[Docket No. FAA-2004-19960; Directorate Identifier 2004-CE-47-AD]

#### Airworthiness Directives; The New Piper Aircraft, Inc. PA-34 Series Airplanes

**ACTION:** Notice of proposed rulemaking (NPRM).

**SUMMARY:** The FAA proposes to supersede Airworthiness Directive (AD) 93-24-14, which applies to all The New Piper Aircraft, Inc. (Piper) PA-34 series airplanes. AD 93-24-14 currently requires you to repetitively replace the bolt and stack up that connect the upper drag link to the nose gear trunnion. This proposed AD is the result of many service difficulty reports related to the collapse or inadvertent retraction of the nose landing gear (NLG). Consequently, this proposed AD would retain the actions required in AD 93-24-14 until the actions of the proposed AD would begin, require you to inspect the NLG and components of the NLG using new procedures for rigging the nose gear installation, and require you to replace unserviceable parts. We are also issuing this proposed AD to detect, correct, and prevent future failure in certain components of the NLG, lack of cleanliness of the NLG due to inadequate maintenance, or lack of lubricant in the NLG or NLG components. This failure of th

Figure 1

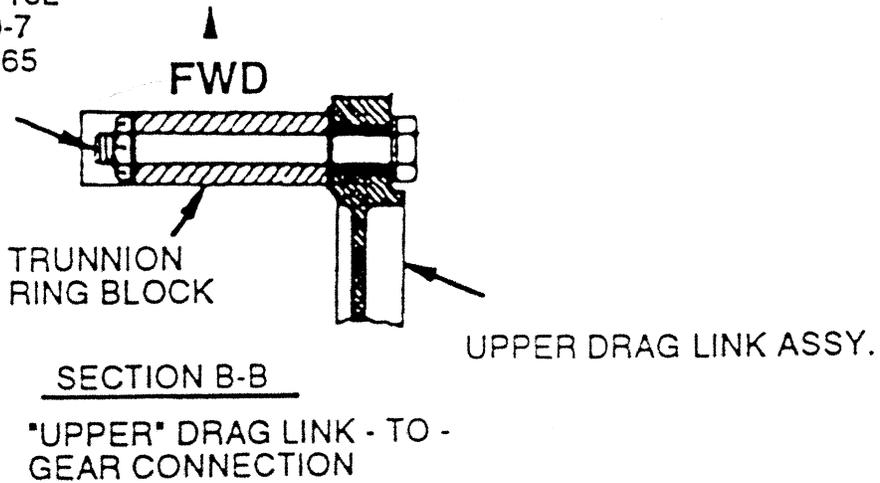
Actions	Compliance	Procedures
(1) Replace the bolt and stack up that connects the upper drag link to the nose gear trunnion with new parts of the following: (i) Piper part number (P/N) 400 274 (AN7-35) bolt; (ii) Piper P/N 407 591 (AN960-716L) washer, as applicable; (iii) Piper P/N 407 568 (AN960-716); (iv) Piper P/N 404 396 (AN320-7) nut; and (v) Piper P/N 424 085 cotter pin.	Within the next 100 hours time-in-service (TIS) after January 28, 1994 (the effective date of AD 93-24-14), unless already done within the last 400 hours TIS before January 28, 1994 (compliance with AD 93-24-14). Repetitively replace thereafter at intervals not to exceed 500 hours TIS. Continue to repetitively replace until the actions in paragraph (e)(2) and (e)(3) of this AD begin.	Follow Figure 1 of this AD.

AN7-35  
AN960-716  
OR  
AN960-716L  
AN320-7  
MS24665
